Model: Phoenix II /Cattleya/Iris/Lilac (ADF)		Date: 15-Sep-99	No.: RA204010
Subject: ADF Jam		Prepared by: H.Matsui	
From: Technical Service Dept., GTS Division			
Classification:	<input checked="" type="checkbox"/> Troubleshooting	<input type="checkbox"/> Part information	<input type="checkbox"/> Action required
	<input type="checkbox"/> Mechanical	<input type="checkbox"/> Electrical	<input type="checkbox"/> Service manual revision
	<input type="checkbox"/> Paper path	<input type="checkbox"/> Transmit/receive	<input type="checkbox"/> Retrofit information
	<input type="checkbox"/> Other (     )

No.: RA204010

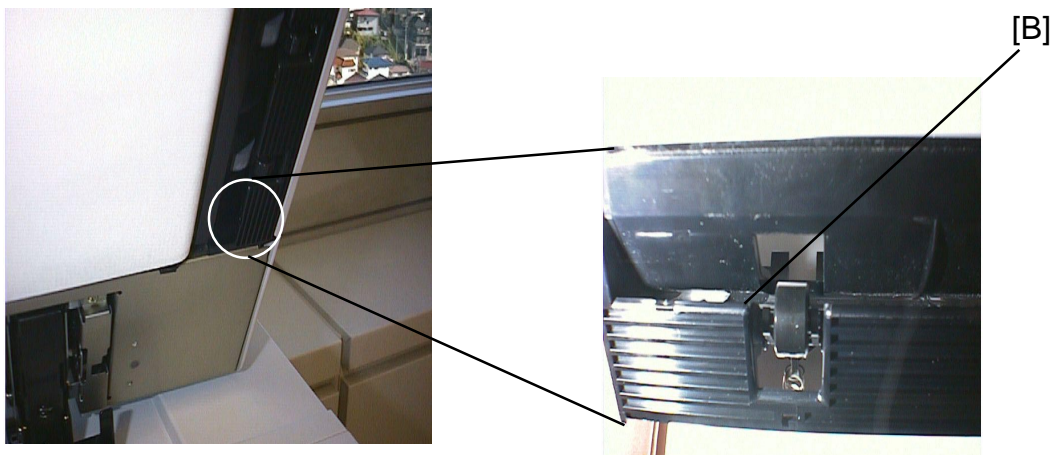
When feeding small size originals lengthwise, a original jam may occur in the area on the exposure glass where the original is to be fed out (position [A]).

The rear side of the leading edge of the originals catches ridge [B] (this ridge was created during the molding process), near one of the ribs of the paper inverter guide plate (P/No. A5481210).

Until the permanent countermeasure is implemented, the ridge [B] should be smoothed down (remove if possible) with sandpaper.

From the serial numbers in the following table, a permanent countermeasure will be applied (the mold used to produce the inverter guide plate will be repaired). Therefore, the above action should not have to be done.
